World Forum for Harmonization of Vehicle Regulations

Proposal for Supplement 11 to the 01 series of amendments to UN Regulation No. 101 (CO₂ emission/fuel consumption)

Submitted by the Working Party on Pollution and Energy*

Figure 1
NEDC test cycle

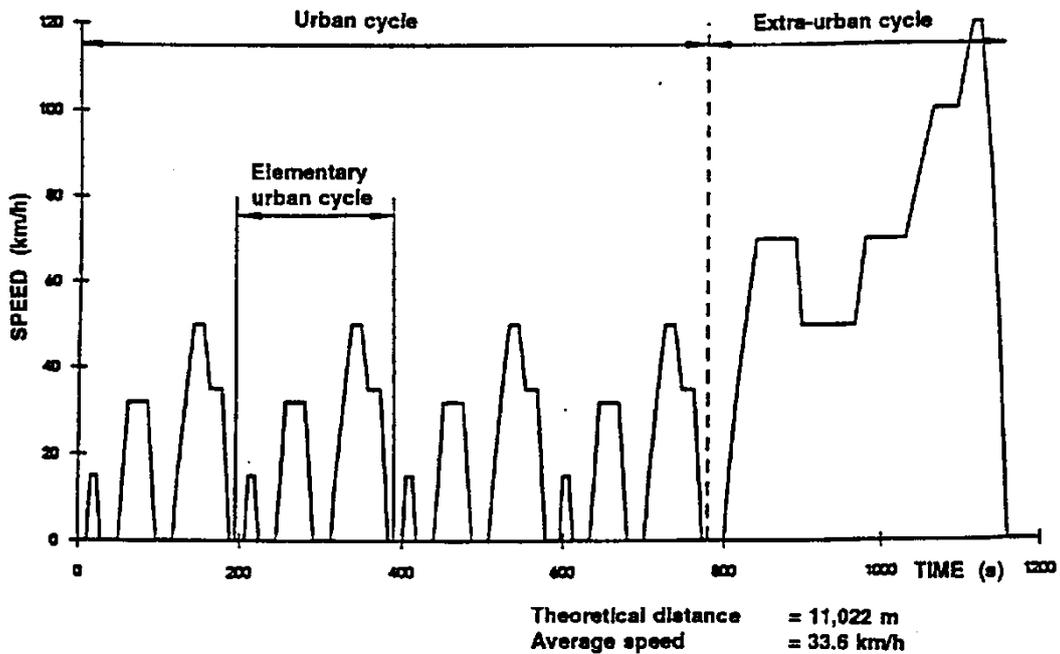
Paragraphs 1., 1.1., 1.2. and 1.3., renumber as paragraphs 2., 2.1., 2.2. and 2.3. respectively and amend to read:

The NEDC test cycle is composed of two parts (see Figure 1):

Figure 3a
Shortened NEDC test sequence

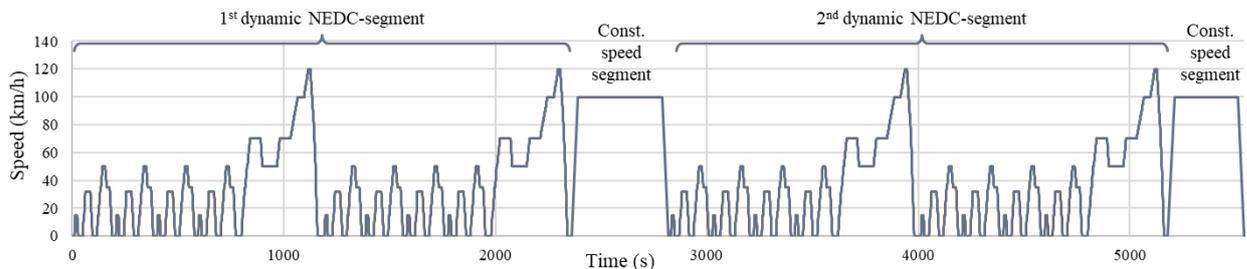
Insert new paragraph 3., to read:

The shortened NEDC test sequence consists of two dynamic NEDC-segments (DS₁ and DS₂) combined with two constant speed segments (CSS_M and CSS_E) as shown in the following figure.

The dynamic NEDC segments DS₁ and DS₂ are used to calculate the electric energy consumption. The constant speed segments CSS_M and CSS_E are intended to reduce test duration by depleting the REESS more rapidly than driving consecutively NEDC test cycles.
